Referee #1

Referee #3

Assimilation of SMOS Brightness Temperatures or Soil Moisture Retrievals into a Land Surface Model

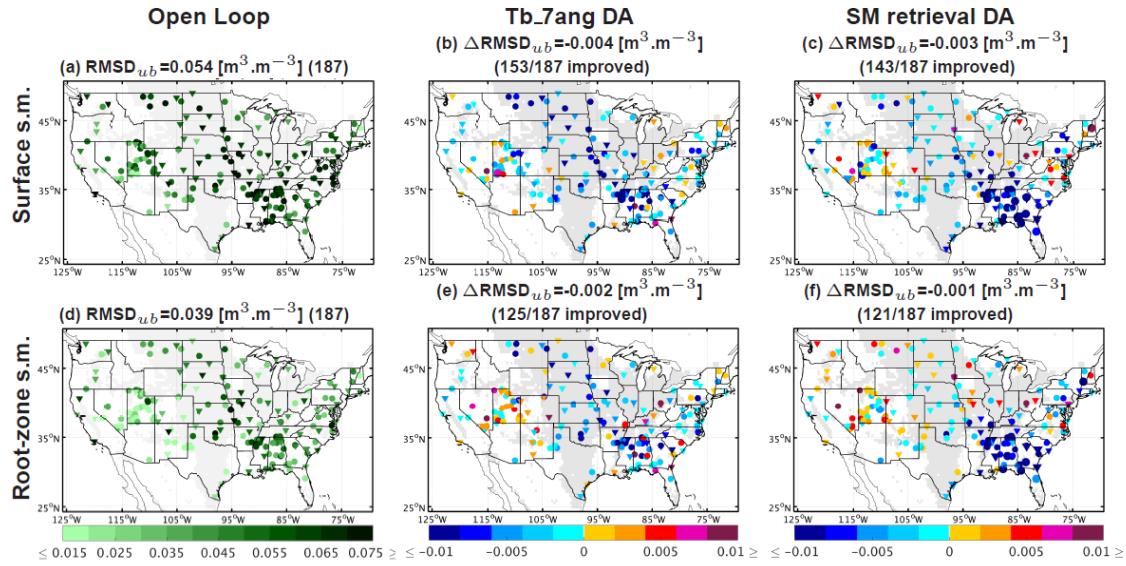
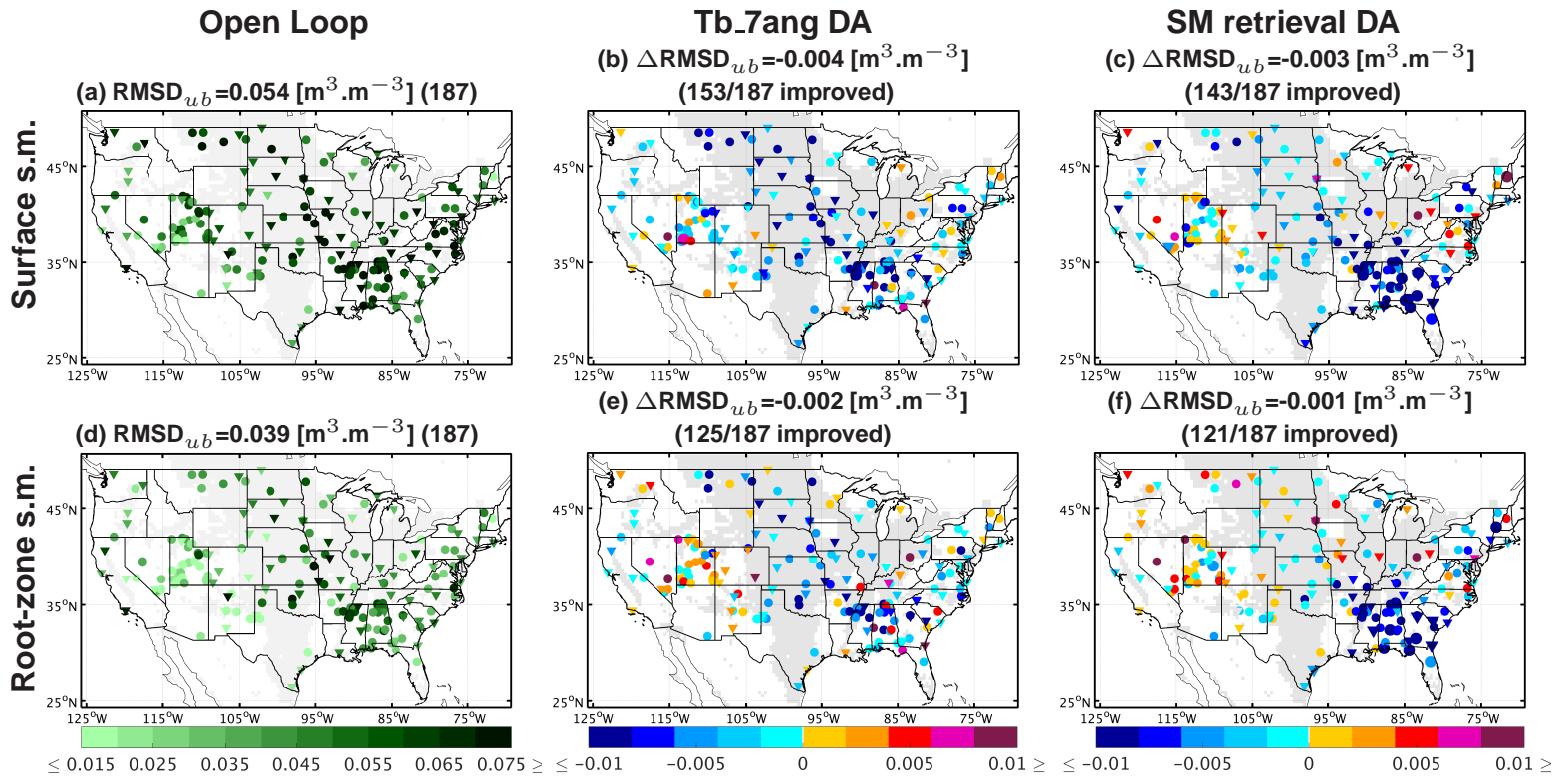
3) Figure 7 indicates the changes due to assimilation. Large marks are assigned for statistically significant sites but it is really hard to distinguish them from the rest. Maybe the authors could use other symbols or give some explanations on how many sites are improved actually. Besides, what is the evaluation of simulation result without data assimilation while only changes are illustrated in Figure 7? I see the magnitude in changes is quite small, about 0.01, which is lower than the accuracy of SMOS/SMAP mission. If the model simulation doesn't match well (for instance, difference larger than 0.1), how important the improvements brought in by assimilation should be re- considered. I know the comparison between model and in-site observation is a very complicated issue and may be too much if it is discussed in this paper. What I recommended is to add some simple figures which could give an estimation of model v.s. observation difference, without assimilation.

We updated the old Figure 7 ([Figure 8]) to also include the RMSD_{ub} values for the open loop simulation, as suggested by the reviewer:

(p.14, L3 [p.14, L13]) “Figure 8 shows the RMSD_{ub} (section 2.4) for the model-only open loop (OL) simulation, and the change in RMSD_{ub} ...”

[p.14, L17] “The OL simulation has an average RMSD_{ub} value of $0.054 \text{ m}^3 \cdot \text{m}^{-3}$ for surface soil moisture and $0.039 \text{ m}^3 \cdot \text{m}^{-3}$ for root-zone soil moisture. Looking more closely, the RMSD_{ub} values are generally higher in the central and wetter eastern regions. In dry areas, the RMSD_{ub} is limited, because the time series show a limited variability for lack of much precipitation....”

[p.14, L25] “The domain-average Δ RMSD_{ub} values caused by assimilation are only barely statistically significant for surface soil moisture in ‘favorable’ areas, i.e. where the satellite observations are most sensitive to soil moisture (indicated with green background shading in Figure 8). The differences between T_b Δ ang, T_b Δ fit or SM retrieval assimilation are not significant. The assimilation contributes an average relative improvement in

surface soil moisture of 7% of the OL RMSDub in favorable locations and 4% in non-favorable areas. Both Tb and SM retrieval assimilation show improvements in the central and eastern parts of the US, but perform poorly in the western dry mountain areas, where the RMSDub for the OL was small and the assimilation may have introduced some additional noise. The Tb_7ang assimilation shows the largest improvements in the central US, whereas the SM retrieval assimilation shows the largest improvements in the southeastern part, for both surface and root-zone soil moisture....”

“Figure 8: Unbiased RMSD (RMSDub) for the model-only open loop (OL) simulation, and change in unbiased RMSD (Δ RMSDub) due to data assimilation at (circles) SCAN and (triangles) USCRN sites for (a,b,c) surface and (d,e,f) root-zone soil moisture. The skill of (a,d) the open loop simulation is the reference value for the changes in skill due to (b,e) Tb_7ang and (c,f) SM retrieval assimilation. Statistically significant changes are marked by larger symbols (e.g. southeastern US for SM retrieval assimilation). Metrics are calculated across 3-hourly time steps during the period from 1 July 2010 to 1 May 2015. The titles indicate the spatial mean (Δ)RMSDub across all sites with clustering (31 clusters). The gray background shading marks areas with limited vegetation and topographic complexity based on model parameters.”

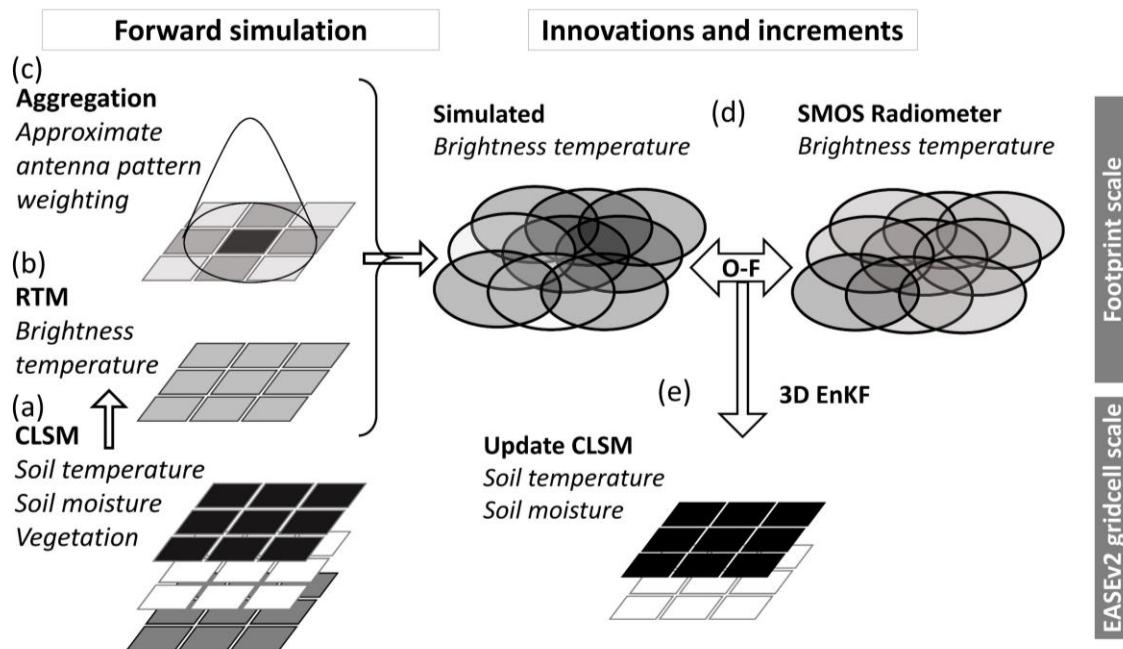
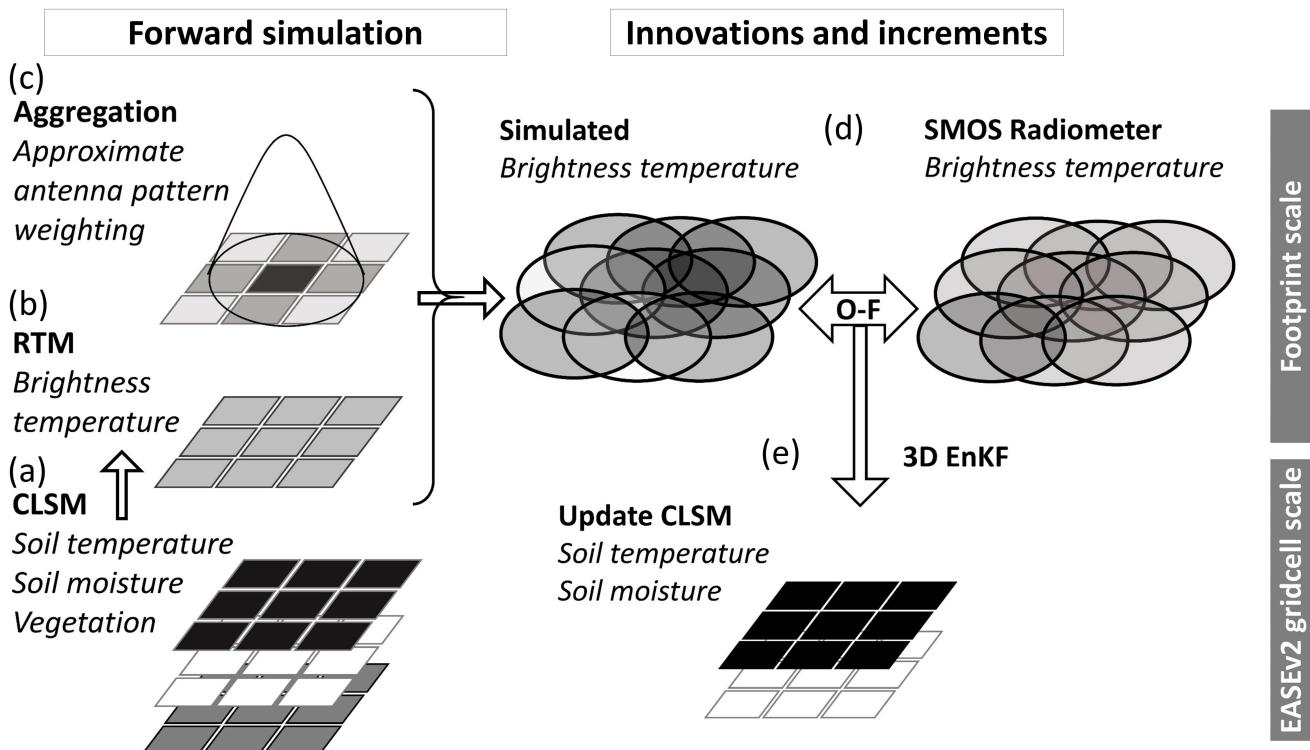
7. Section 2.3, there are lots of information in this subsection. However, it is difficult to follow without further checking other references. More specifically, for the concept of "footprint scale" and 36-km grid, how they were relevant and how exactly they varied with latitude and longitude are not clear. Perhaps a schematic will help? Furthermore, could the authors help to use a flowchart here to show that RTM converted CLSM simulations into

Tb and then this calculated Tb was used to compute O-F residuals in the assimilation system, while considering the geometric relations between "footprint scale" and "36km grid"? Such flowchart will help tremendously the readers to have an overview of the whole processing chain, which is the most fundamental for understanding the topic of this manuscript.

10. section 3.1, again, this is also fundamental for readers to understand the manuscript. Could the authors help to add a flowchart here to show the difference between the Tb and SM assimilation algorithm?

We added a schematic overview of the assimilation algorithm with special attention to the resolutions for clarification:

[p.5, L19]: "(O-F) residuals in the assimilation system (section 3.1, Figure 1)..."

(p.6, L22 [p.7, L16]) "Figure 1 illustrates the forward simulation from 36-km gridded land surface simulations to footprint-scale observation predictions of Tb, and the downscaling of the footprint-scale Tb innovations to 36-km gridded land surface increments."

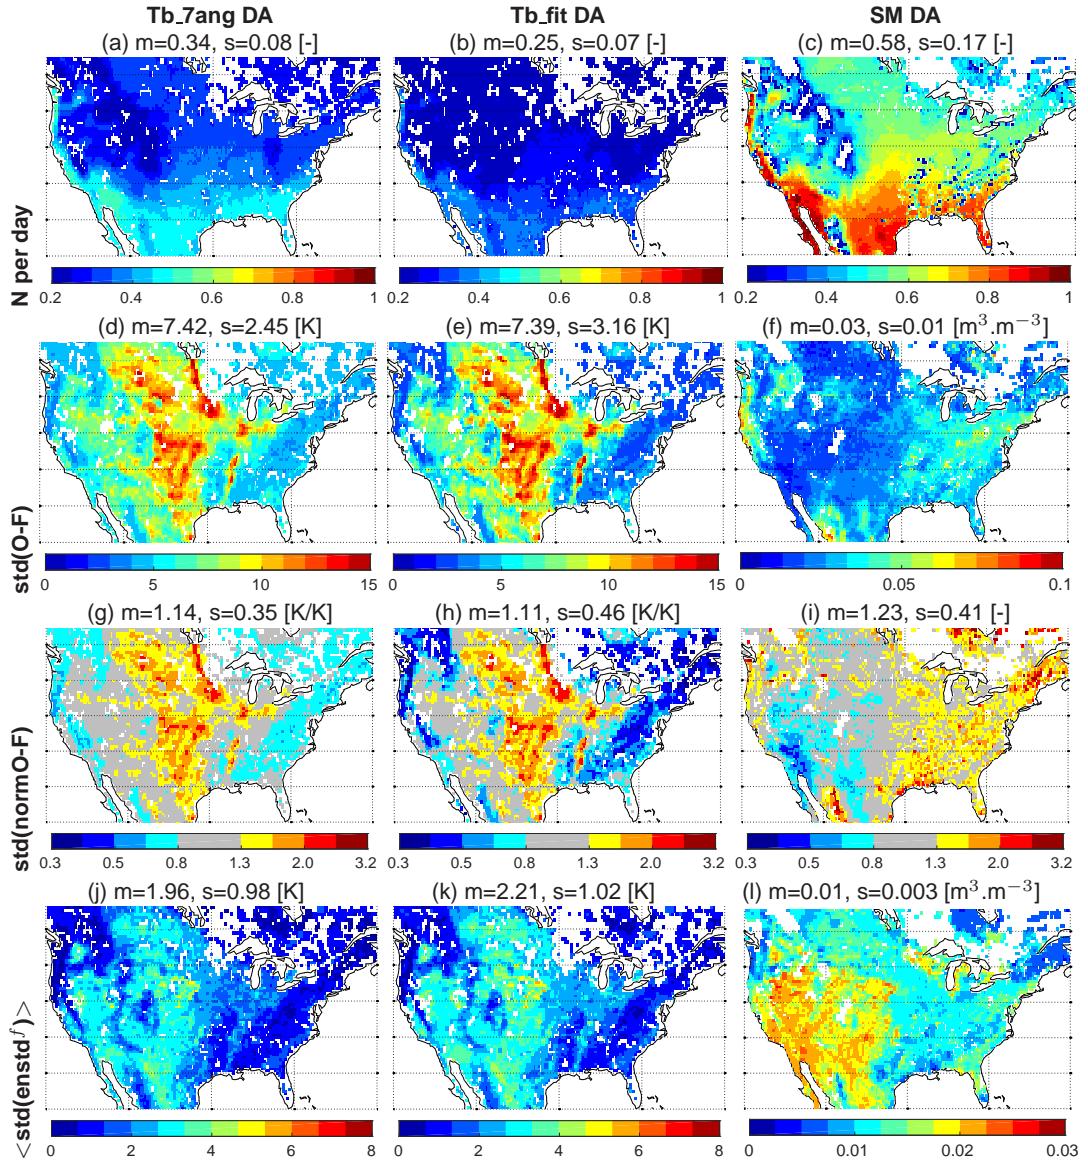
2. P22, Figure 3: should the captions of g, h, and i be for subplots j, k, and l?

(Figure 3 [Figure 4]) Good catch, many thanks.

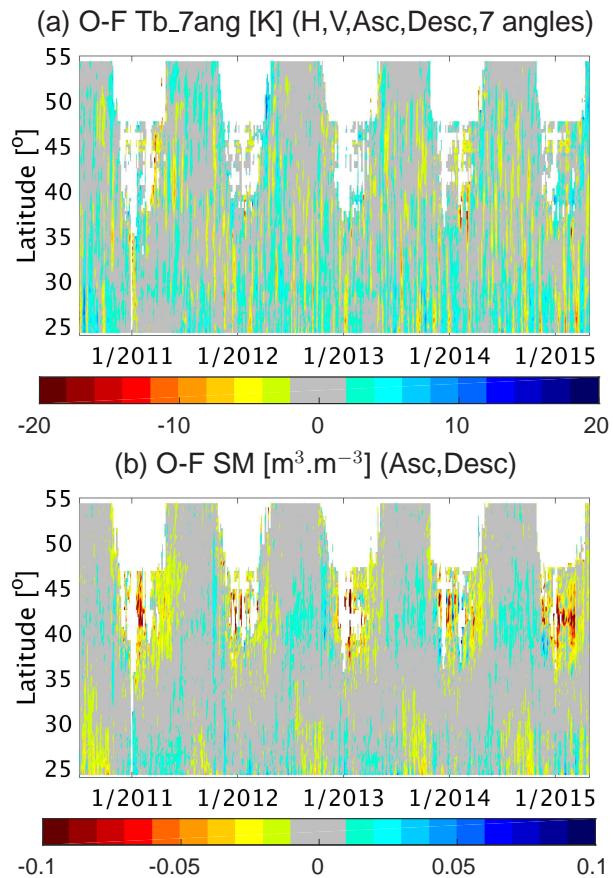
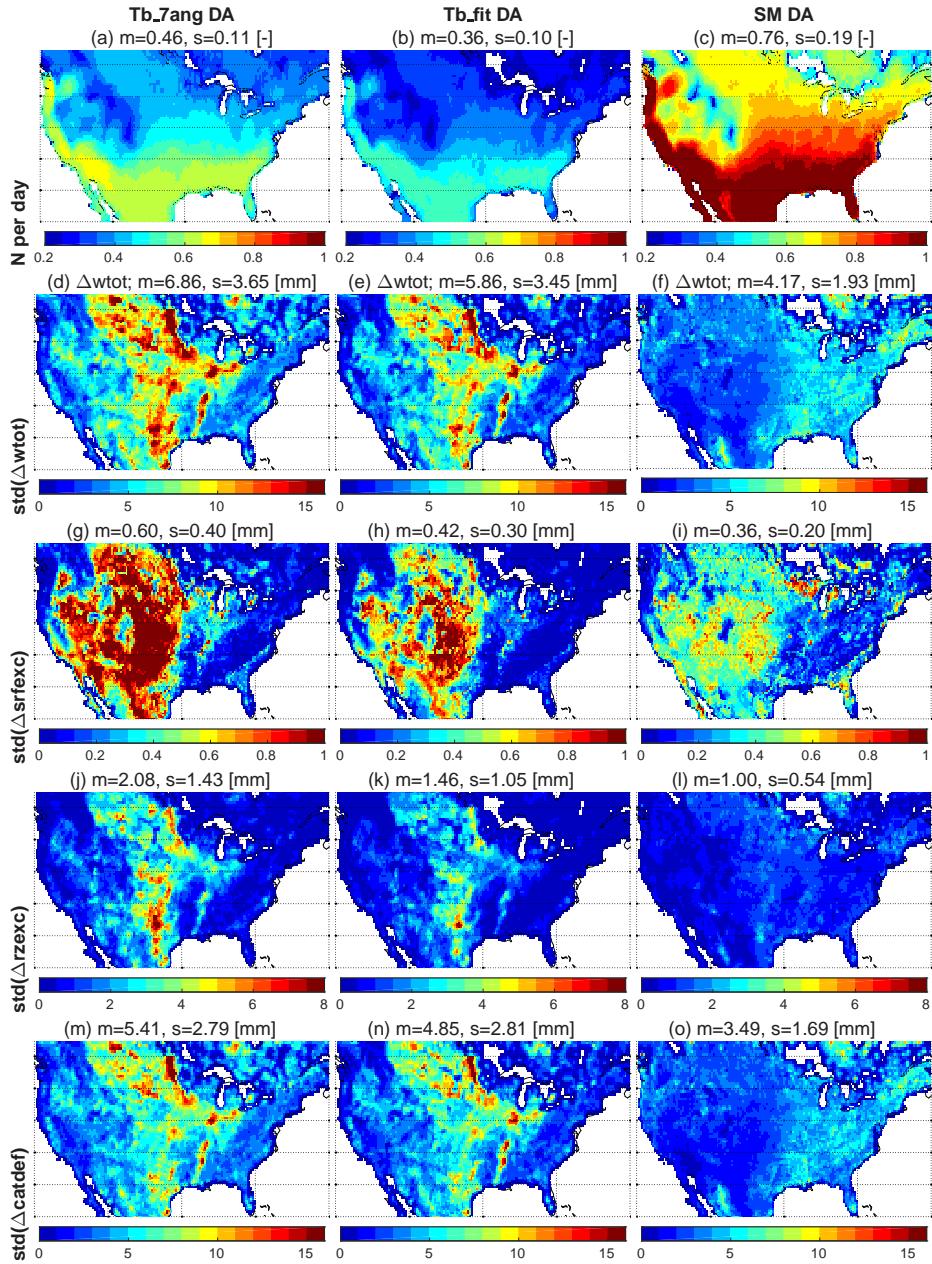
Specific comments: 1. The concept of total soil profile water (Δw_{tot}) was used to investigate the innovations, increments and relevant statistics (e.g. in Figure 1, 2, 5, 6). On the other hand, this Δw_{tot} is a diagnostic variable (e.g. an aggregated variable representing changes in catdef, srfexc, rzexc) and is not a member of the state vector for Tb & SM assimilation. It is not clear if the analysis has been done for catdef, srfexc and rzexc, what is the necessity left (or add value) for doing analysis for Δw_{tot} ?

It is suggested to use catdef for Figure 1,2,5 & 6, instead of Delta_wtot. Or, if the authors would like to stick with their choice, a verification/clarification is needed.

(p.7, L6 [p.7, L26]) "For the discussion of the soil moisture increments we will focus on the total profile water increments ($\Delta w_{tot} = \Delta srfexc + \Delta rzexc - \Delta catdef$) in units of kg m⁻² (or, mm of water equivalent). This quantity is easily understandable and thus simplifies the discussion."

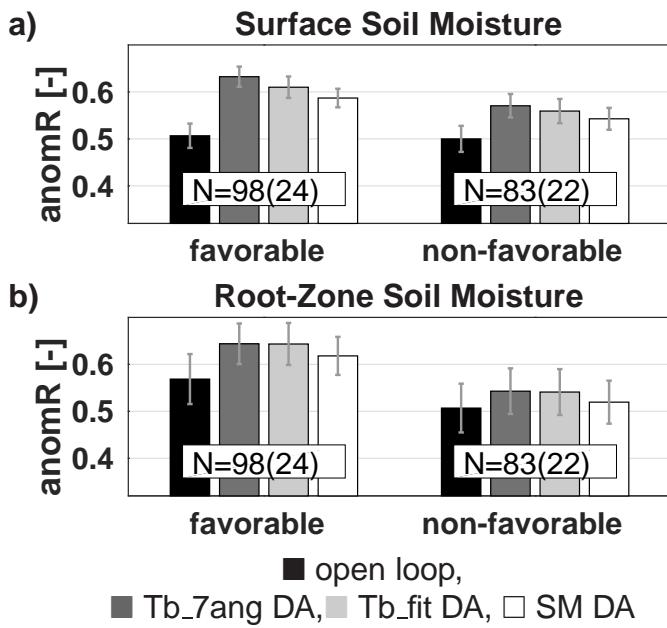
4) For Figure 8, the problem still exists. Figure 8 adopts a similar method used in another paper in De Lannoy and Reichle, Journal of Hydrometeorology, 2016. It is for sure that the correlation increase indicates the effect of assimilation but the correlation increase doesn't mean the absolute soil moisture value is improved. Usually in the current forecast model, soil moisture is a diagnostic variable which does not interact with the atmosphere directly. As mentioned in Line 21 (p.1), if the soil moisture will be used to improve weather forecast, its absolute value is more important for evaporation/Bowen ratio calculation. By enlarging or restricting soil moisture, the land surface model in climate forecast could also collapse while correlation coefficient increases. Without seeing the soil moisture time series for particular site, or at least any time-series which reflect the variation, the conclusion that assimilation improved soil moisture simulation should be made with caution.

It is not 100% clear to us what the reviewer means by improved “absolute soil moisture value.” Our assimilation system is primarily designed to estimate or improve temporal variations of soil moisture by correcting for random errors. The long-term mean soil moisture values from the assimilation are intentionally the same as those of the underlying model. (This implies that the assimilation estimates can still be used in conjunction with the model’s relationship between soil moisture and the Bowen ratio, without upsetting the forecast model’s calibration.) In any case, when the model soil moisture is adjusted by the analysis updates, its absolute value changes at any given time. The correlation and $RMSD_{ub}$ metrics do measure this change (but would not measure a change in the long-term mean, which, again, does not occur by design).

(p.5, L30 [p.6, L7-9]) “...the skill is quantified in terms of anomaly time series correlation (anomR),.... The anomaly correlation is based on anomaly time series obtained by subtracting a multi-year smoothed climatology from both the simulations and in situ observations. Note that the assimilation and open-loop simulations have, by design, the same climatological variability; the assimilation only corrects for random errors.”
